Blackwater Residential Subdivision
Pantex

A MENDED IN RED
- 6 JUN 2012
By: Matt Teo (name)
of the ULDA

PLANS AND DOCUMENTS
referred to in the ULDA
APPROVAL dated 3 / 7 / 12

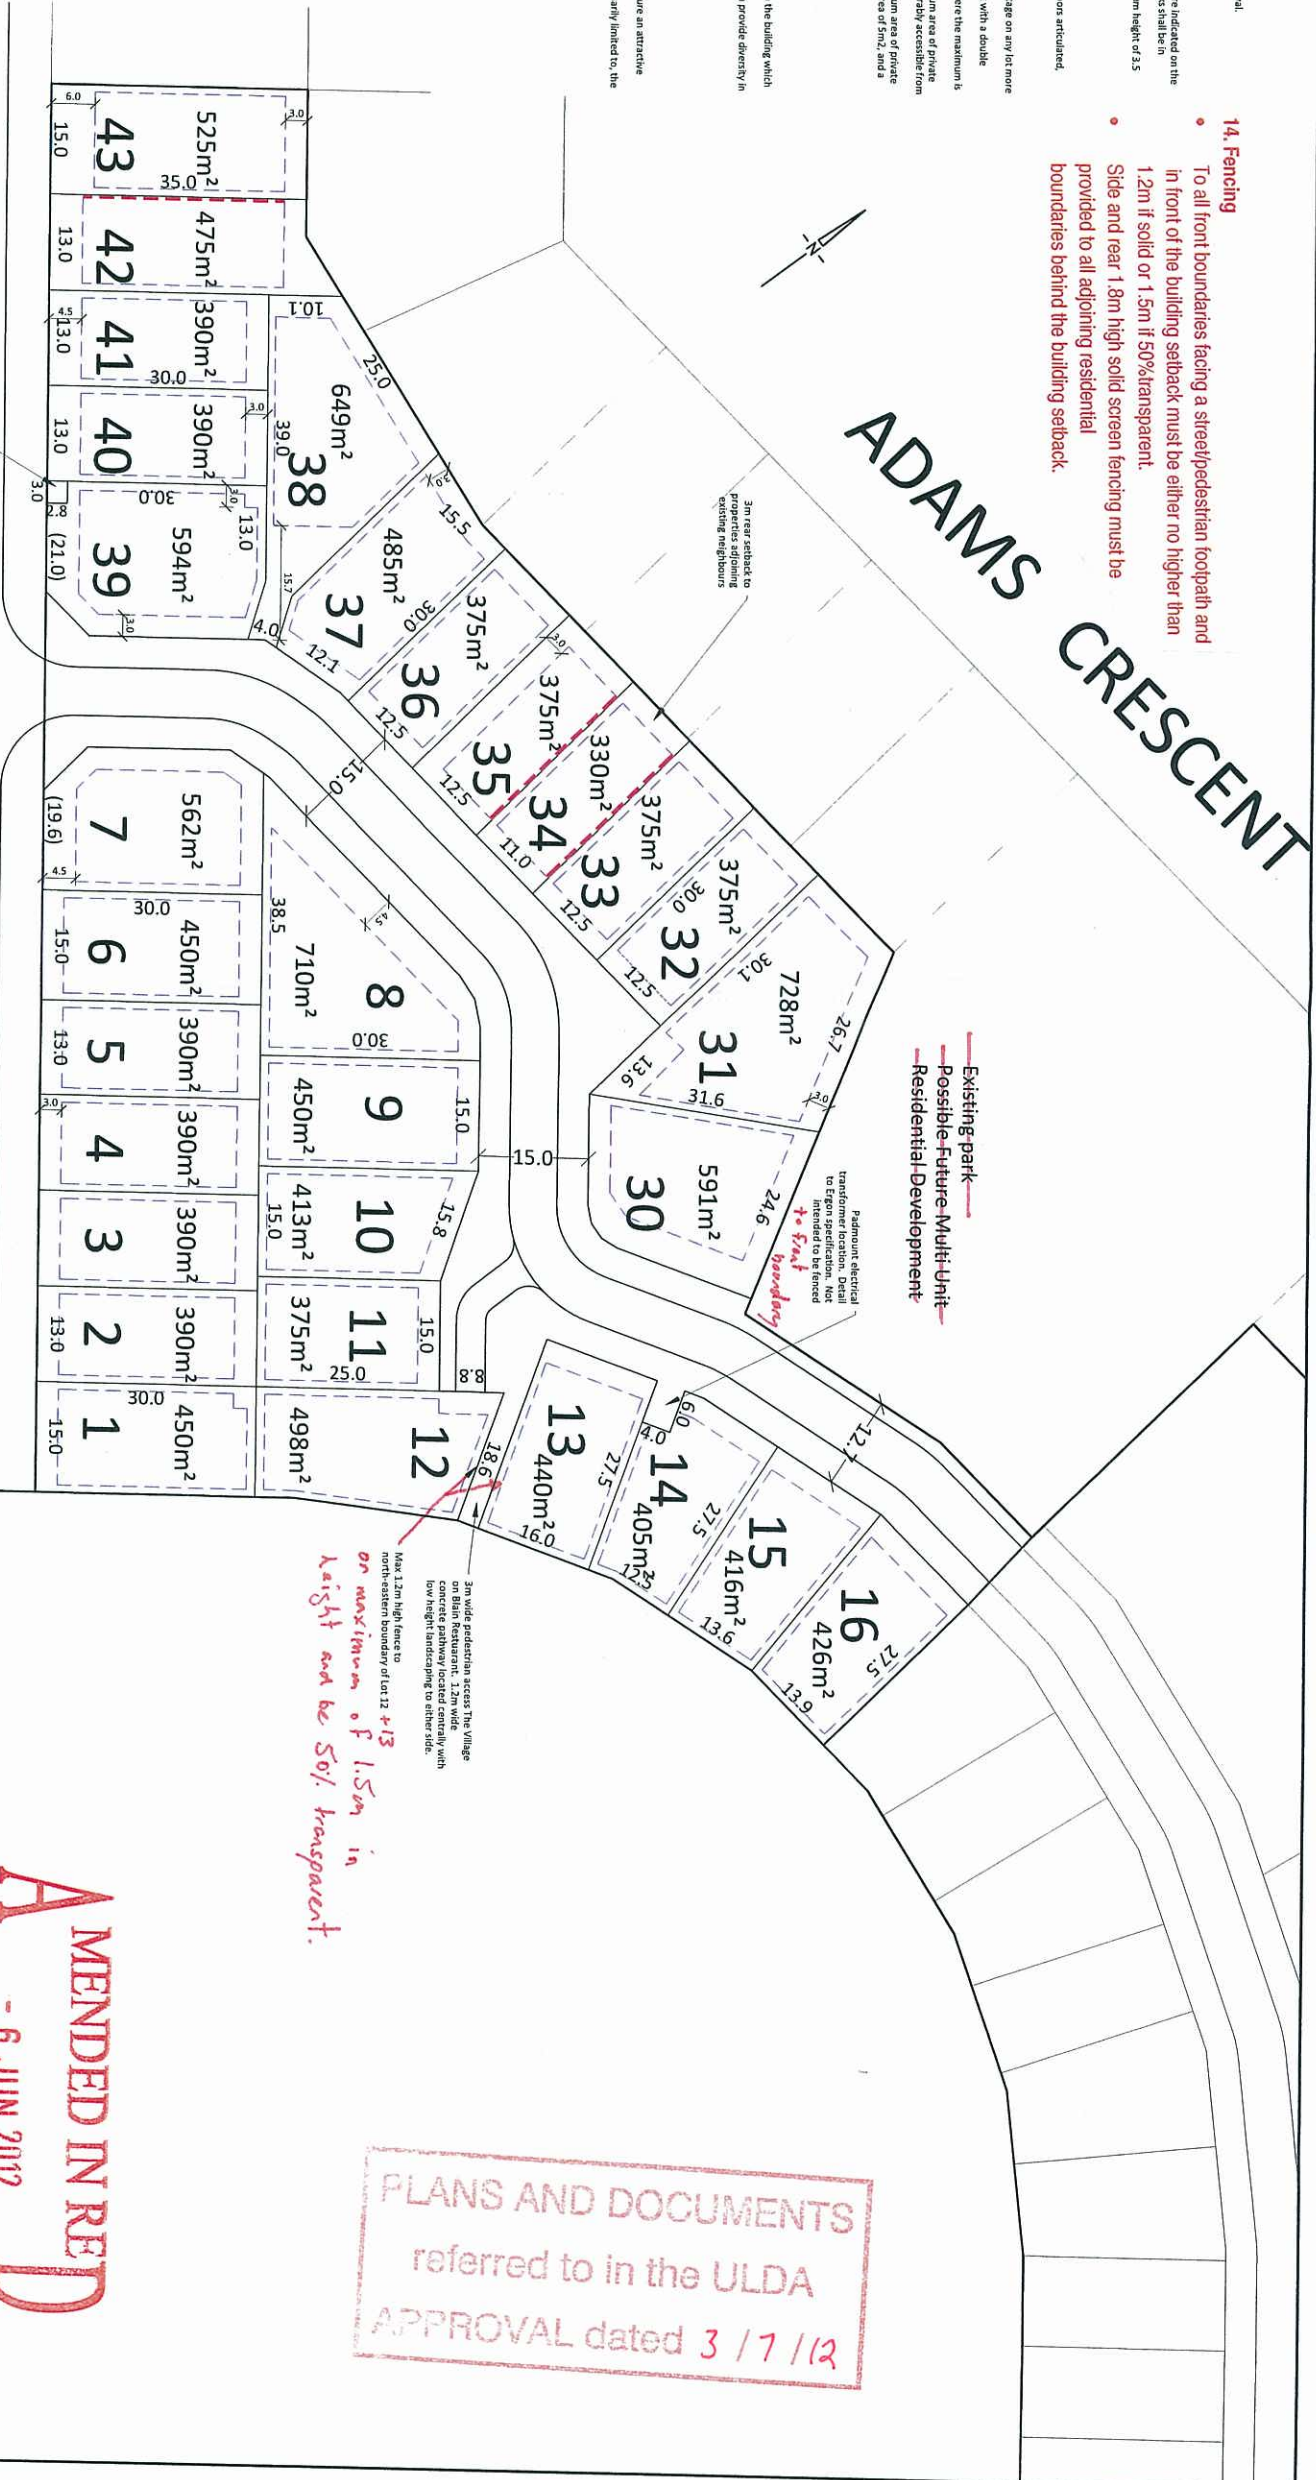
7. A minimum of two (2) off street car park is required per dwelling.
8. All ~~double~~ garages ~~double~~ be setback behind the main face of the dwelling with doors articulated, comprising a mix of materials and colours, or staggered.

Village on Blain

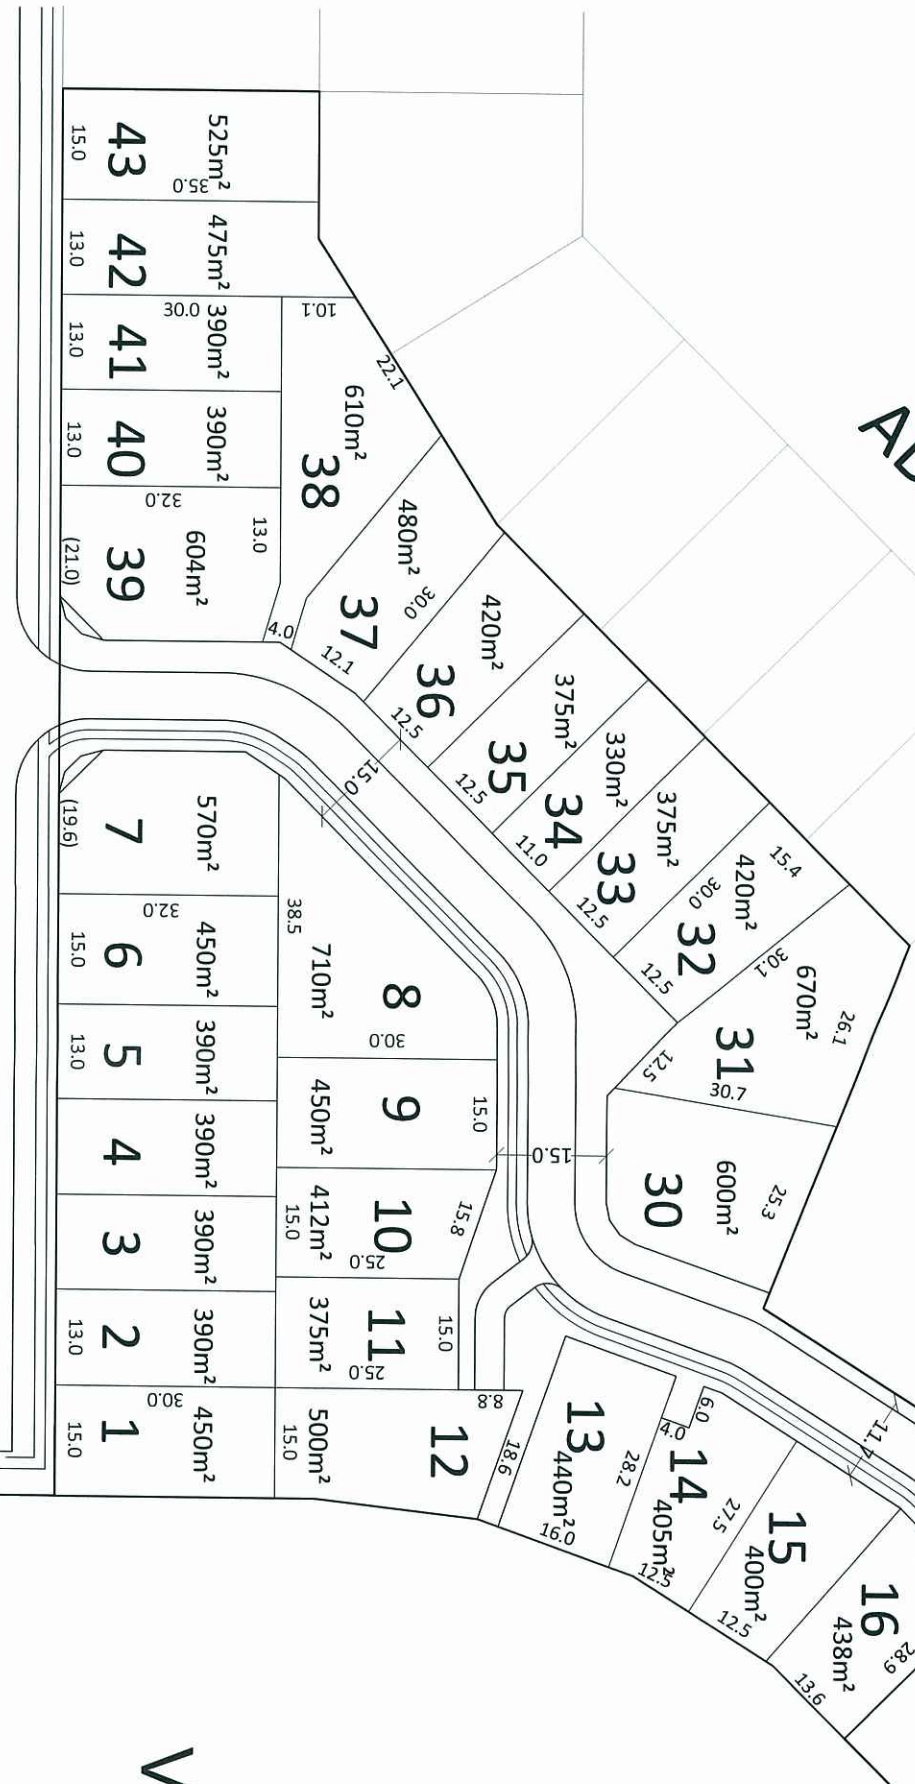
AMENDED IN RED
- 6 JUN 2012

Section A-A
Typical street character

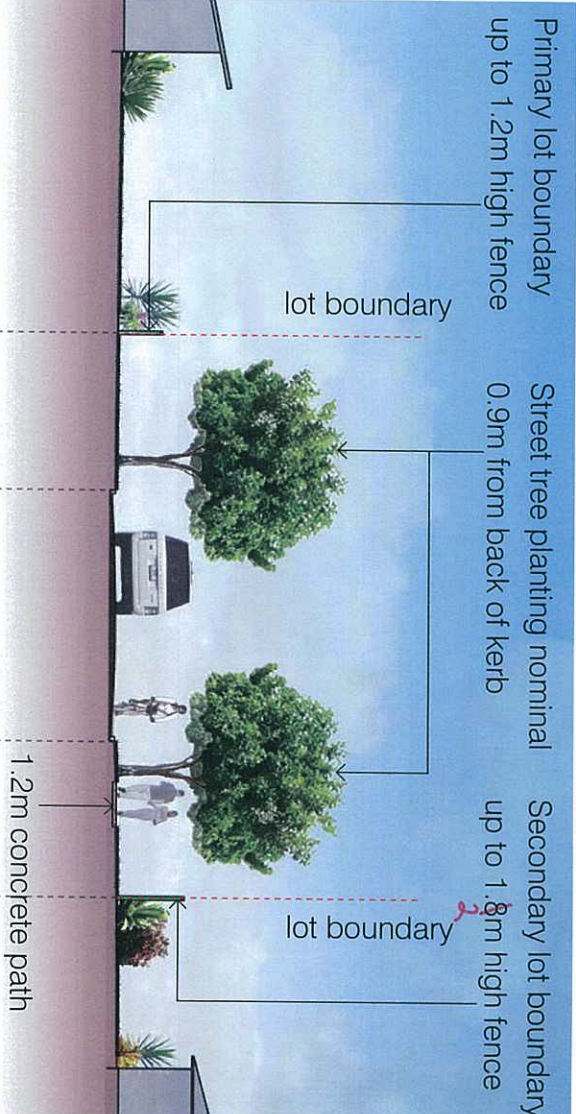
AMENDED IN RED
- 6 JUN 2012
